## COBRA Guidance Note

JFD have had reports of the Handle Manifold becoming loose within the Activation Assembly on the Helmet

#### Handle Manifold becoming loose

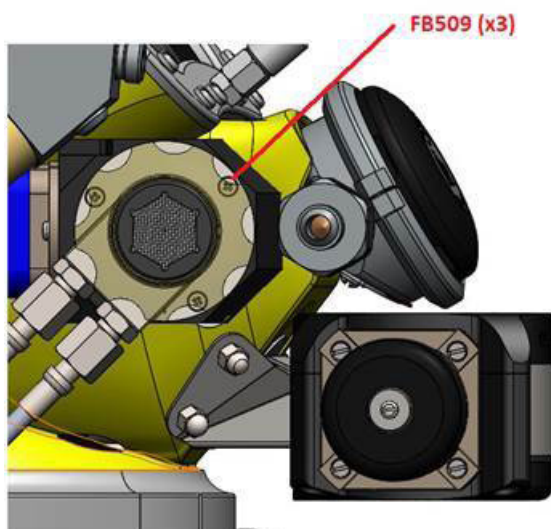
After repeated use, the M3 countersunk screws (pt. no. FB509) used to secure the Handle Manifold can loosen and occasionally unscrew completely, leaving the Handle Manifold insufficiently secured into the Mouthpiece Housing on the helmet.

The general torque stated in the COBRA manual for an M3 screw in a Tappex insert is insufficient in this location. These 3 screws (pt. no. FB509) should be tightened to 8 inch-pounds. Additionally, Loctite 222 should be applied to the countersink area of the screw only. It is important that the Loctite is not applied to the thread of the screw, as this may cause slackening of the insert when the screw is removed.

It can also be advantageous to remove the Activation Handle to allow improved access to these screws.

The torque of 3 inch-pounds for M3 screws remains appropriate for other locations on the COBRA set.
